Only PD affects PD POWERUP Tnrush max.

IEEE802.3bt

Sep 2015

- PD spec: IEEE802.3bt D1.2, Clause 33.3.7.3 page 271 lines 39-43
 - To restore the PD linrush **end** time reference point from IEEE 802.3-2012 to IEEE802.3bt with the necessary changes made for 802.3bt.
 - This is what PD vendor needs for PD design to meet linrush timing
 - PD linrush **end** time reference point in D1.2 is different than IEEE 802.3-2012 and physically is incorrect although the time duration is correct.

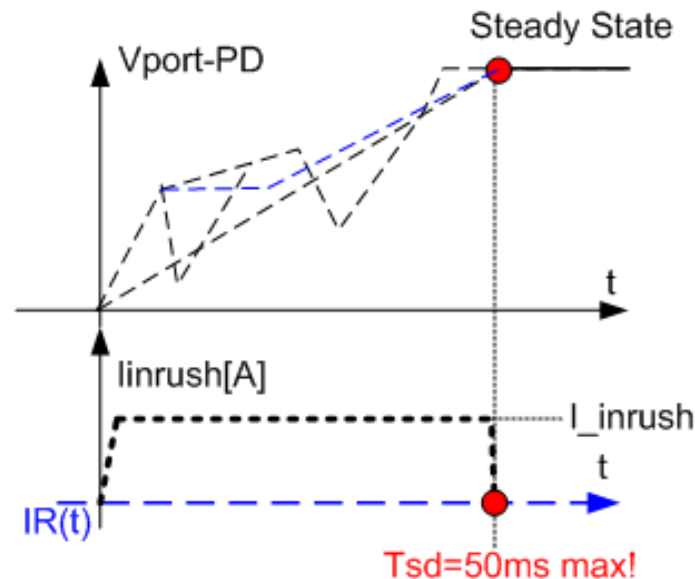
and ending before TInrush-2P min per Table 33–11.

The ending point is incorrect:

The ending point should depend on PD physics (getting to steady state by charging to 99% of Cport) and not on PSE inrush timer!

We do need to specify TInrush_min as maximum time duration for Inrush process in separate row and not as the process end point!

This part should describe a process: the Inrush start and end time

and ending when CPort has reached a steady state and is charged to 99 % of its final value.

This period should be ended before TInrush-2P min per Table 33-11.

■ Suggested Remedy (changes are in RED)

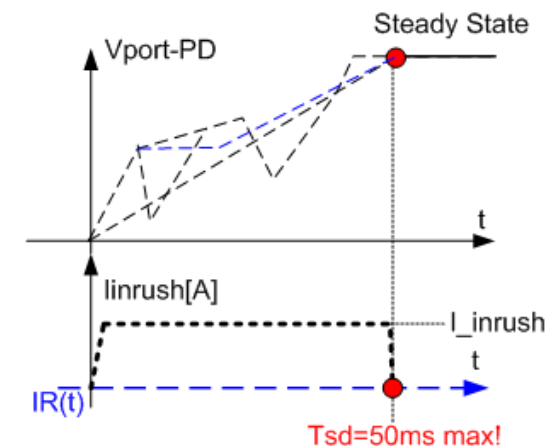
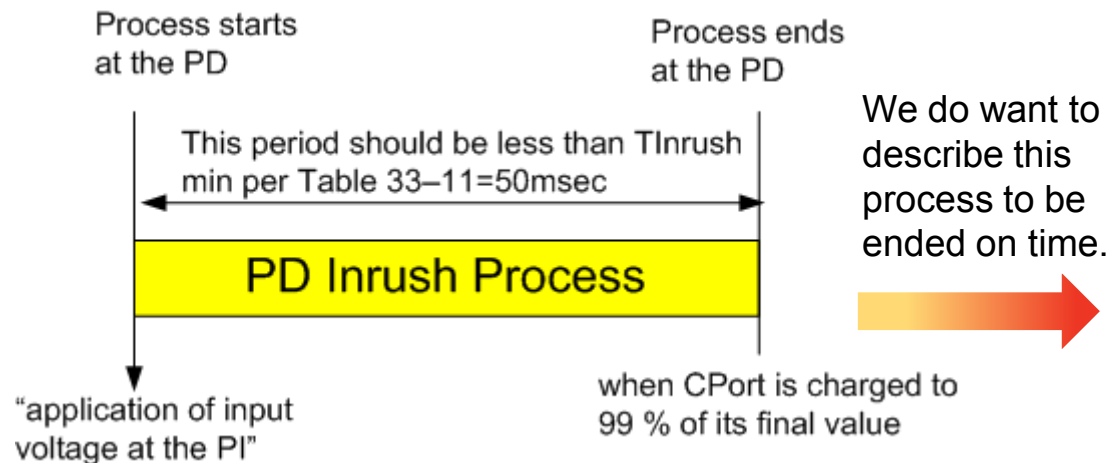
Inrush current per pairset is drawn beginning with the application of input voltage at the pairset compliant with Vport_PD-2P requirements as defined in Table 33–18, and ending **when CPort has reached a steady state and is charged to 99 % of its final value.**

This period should be ended before TInrush-2P min per Table 33–11.

Note: For successful startup, a PSE supplying linrush-2P minimum value and a PD not drawing more than Type 1 maximum DC current results in stable voltage ramping across the PD input capacitor which is important for successful POWER UP. In addition, Cport value and PD load current may be time dependent. As a result PD implementers need to ensure that for any combinations of Cport and Type 1 maximum DC current during POWERUP, the PD inrush period is not exceed 50msec and higher PD load power should be used only after Tdelay.

Annex B: PD Cport possible variations during POWERUP time duration

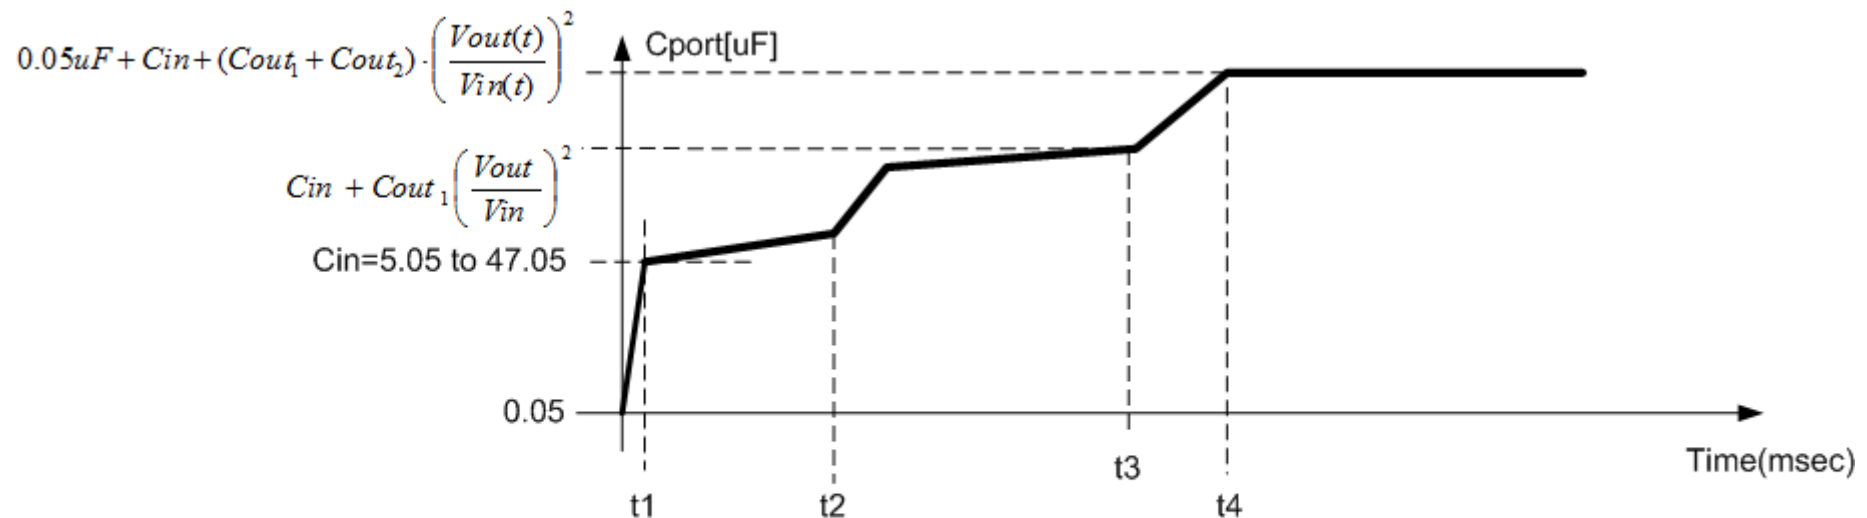
1. t_1, t_2, t_3 and t_4 are implementation specifics.
2. Slopes of capacitance change is function of DC/DC transfer function and soft start.

- Regardless of actual C_{port} profile (implementation specifics), PD must get to steady state ($V_{port-PD} dv/dt \rightarrow \varepsilon$, practical $\varepsilon \cong 0.01$) within 50msec.
- Only PD physics affect the completion of PD Inrush.
- PSE Tinrush timer has no effect on the completion of PD inrush time.

Annex C: compliant PD test setup for testing PSE POWERUP Inrush and Tinrush requirements

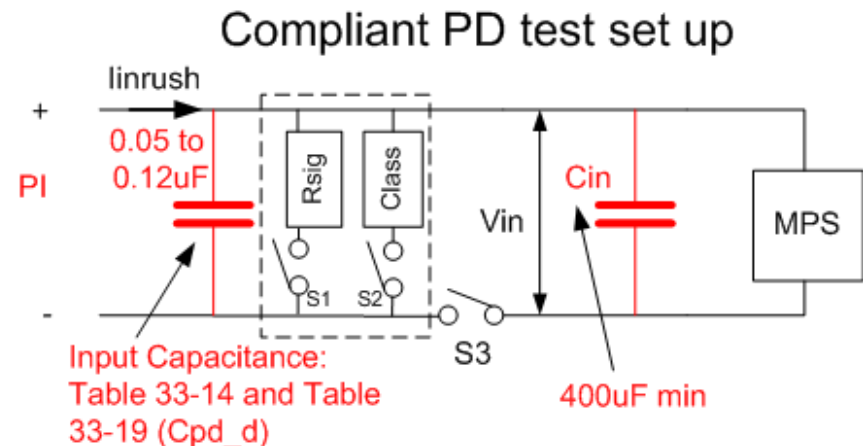
- PSE has to supply startup energy for the worst case conditions.
- The PD test setup will contain big capacitor at its input so Inrush can be monitored for at least 50msec.
- Worst case STARTUP energy is given by:

- $0.5 \cdot V_{pse_max} \cdot I_{inrush_max} \cdot T_{inrush_min} = 0.5 \cdot C \cdot V_{pse_max}^2$.
Resulting with $I_{inrush_max} \cdot T_{inrush_min} = C \cdot V_{pse_max}$

- C_{in_min} in the test setup is:
 $I_{inrush_max} \cdot T_{inrush_min} / V_{pse_max} = 0.45 \cdot 0.05 / 57 = 394 \mu F$.

- Use 400uF min and measure Iport that is within I_{inrush_min}/max range for at least 50ms.
